City of Albuquerque

RE: DRAINAGE PLAN FOR AN ADDITION TO 708 MARQUETTE NW (J14-D106)
ENGINEER'S STAMP DATED 4/13/94.

DRAINAGE REPORT
FOR
OFFICE BUILDING ADDITION
7TH ST. AND MARQUETTE AVE.

Figure 2 - Developed Site Plan (Plate 3)

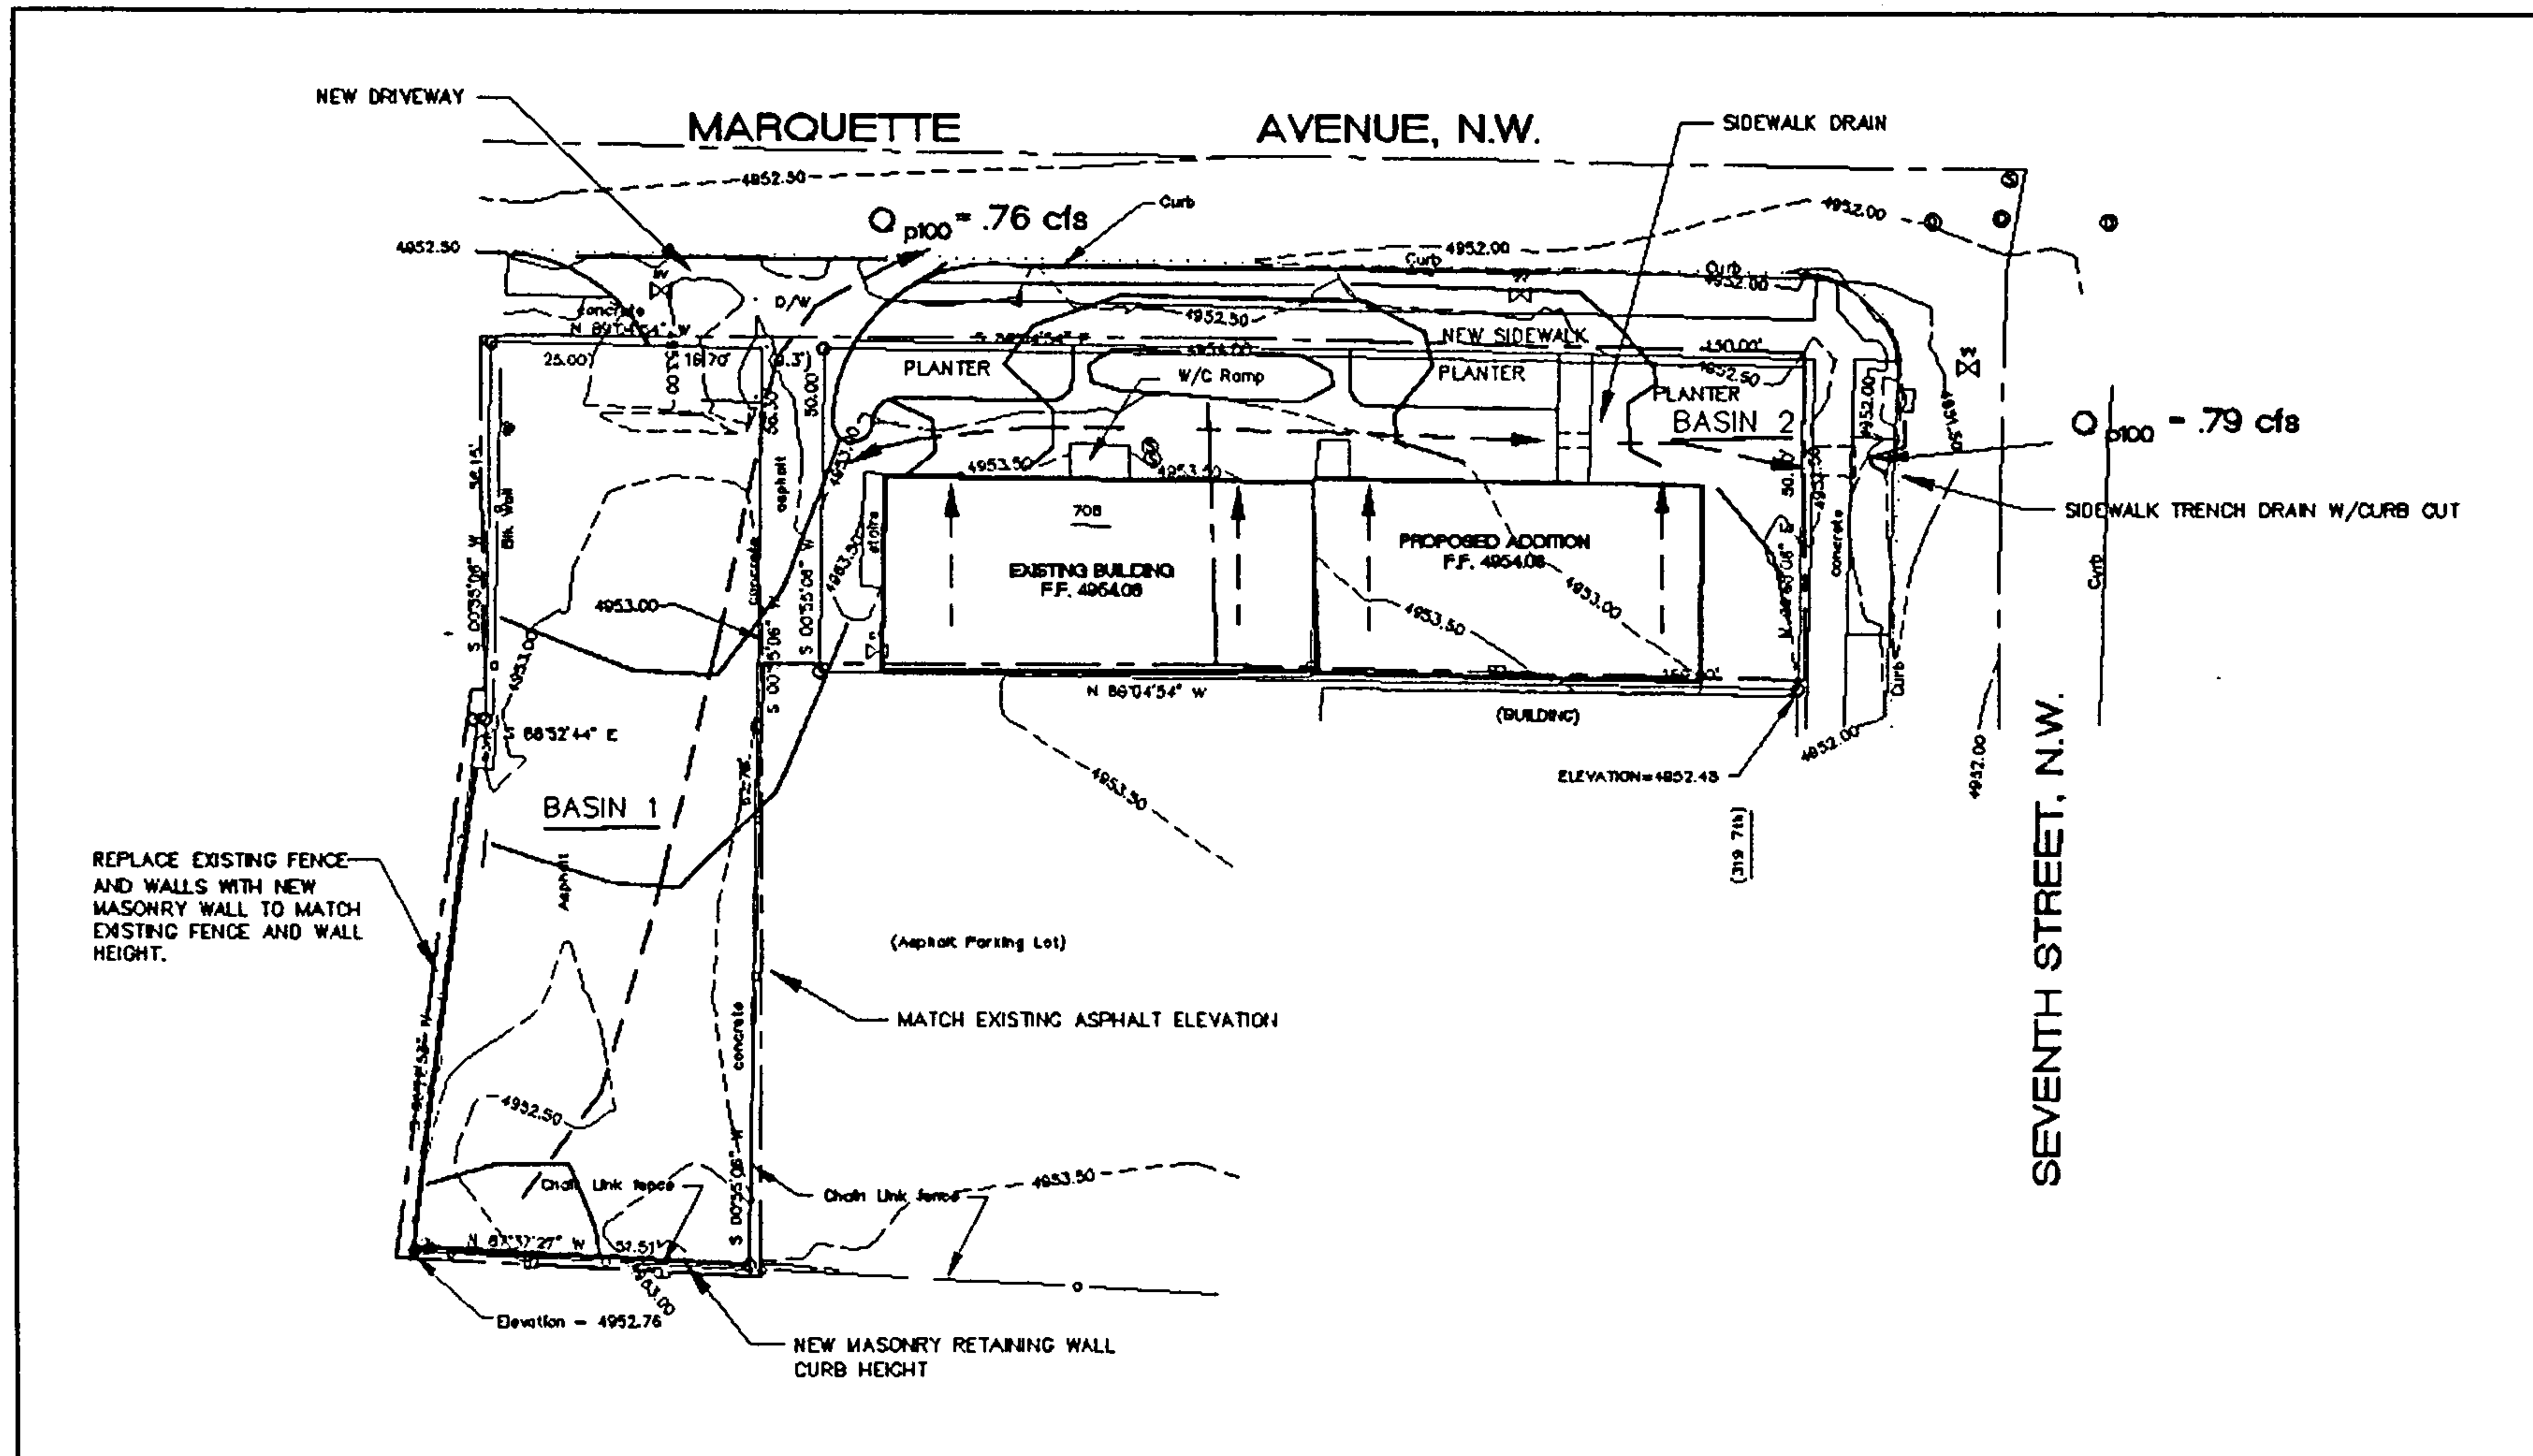
2. top of curb and flowline elevations on Marquette & Seventh St.
3. Your report identifies that you have a total of .689 cfs existing and .634 cfs proposed flow rates. The plan drawing indicates .76 cfs from basin 1 & .79 cfs from basin 2. I am confused to the difference in the quantities. Pre-design indicates that you are limited to the existing flow rate.

4. The S.O. 19 format for the proposed sidewalk culvert must be included on the plan drawing. The six notes and the sign-off block. You must also identify the City of Albuquerque Spec. No. for the sidewalk culvert (attached). This information must be on the plan drawing. Two copies of plan with the resubmittal.

5. Replat or paper easement for cross lot line drainage.
6. Please be advised that no developed run-off is allowed over and across a public sidewalk. Either a sidewalk culvert or a drivepad must be used.
